**TOWN OF PORTOLA VALLEY  
ARCHITECTURAL AND SITE CONTROL COMMISSION (ASCC)  
Monday, November 26, 2012  
Special Field Meeting (time and place as listed herein)  
7:30 PM – Regular ASCC Meeting  
Historic Schoolhouse  
765 Portola Road, Portola Valley, CA 94028**

**TO:** ASCC  
**FROM:** Tom Vlasic, Town Planner  
**DATE:** November 20, 2012  
**RE:** Agenda for November 26, 2012 ASCC Meeting

**4a. REVIEW FOR CONFORMITY WITH PROVISIONS OF CONDITIONAL USE PERMIT (CUP) X7D-30, GARDEN ENTRY PAVILION AND GARDEN, 302 PORTOLA ROAD, THE PRIORY SCHOOL**

Entry Gate- Enright Residence  
Sheet A1.01 171 Mapache Drive  
Portola Valley, CA

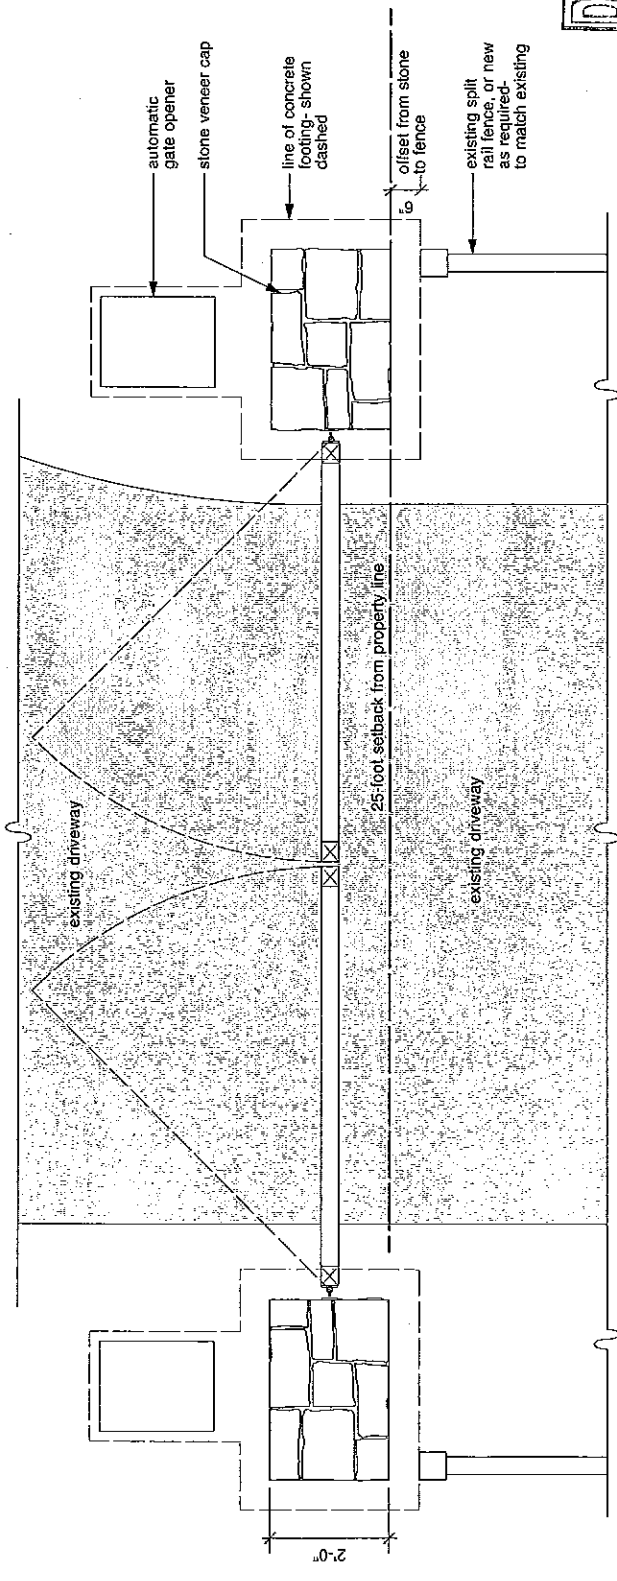
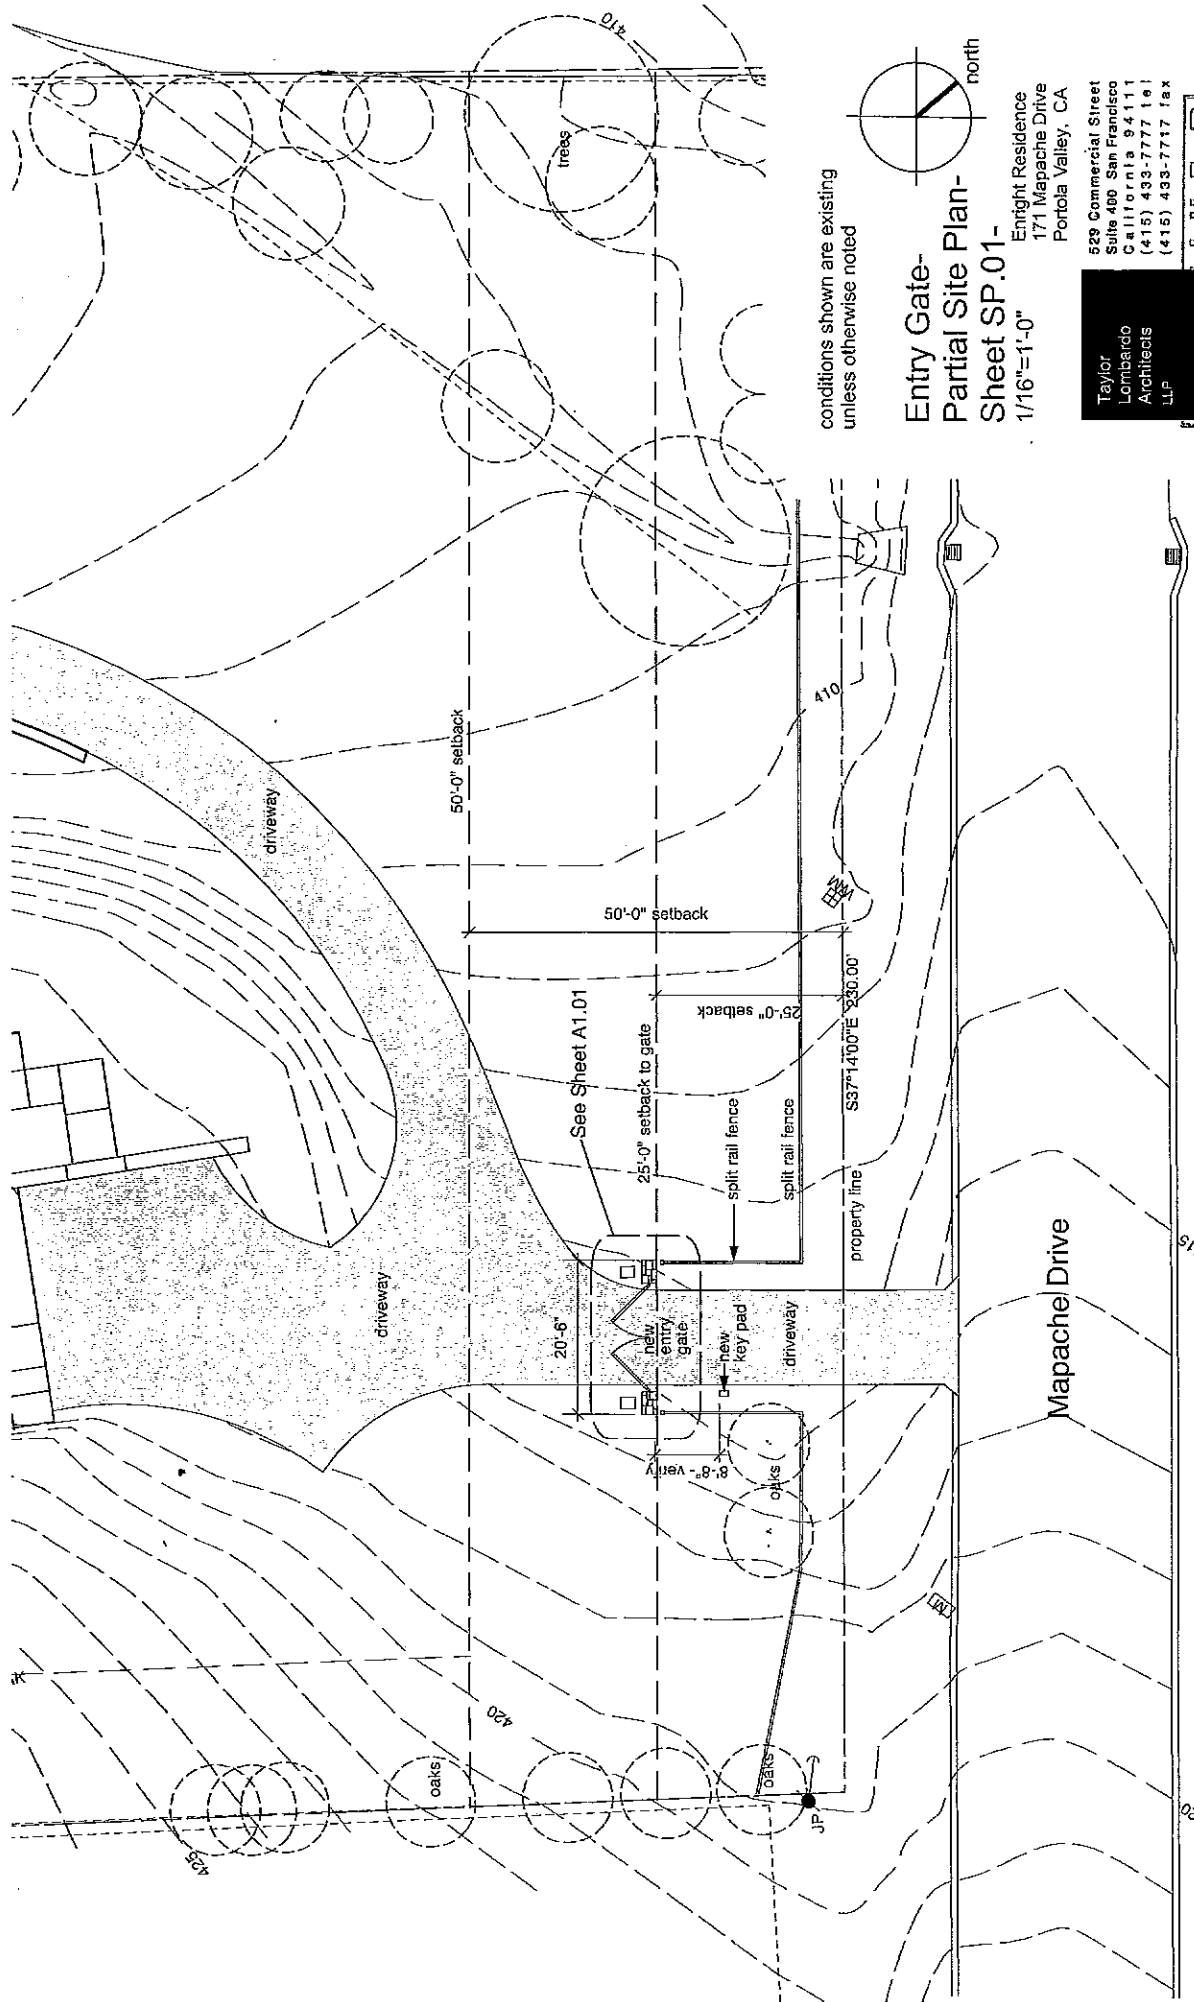
The opacity limit for gates within the front yard (or in side yards along street frontages) is 50%. Sheet G0.01 provides detailed measurements and illustration that the gate meets this requirement. Both the gate and columns have a maximum height of 4 feet, meeting the ordinance height limit.
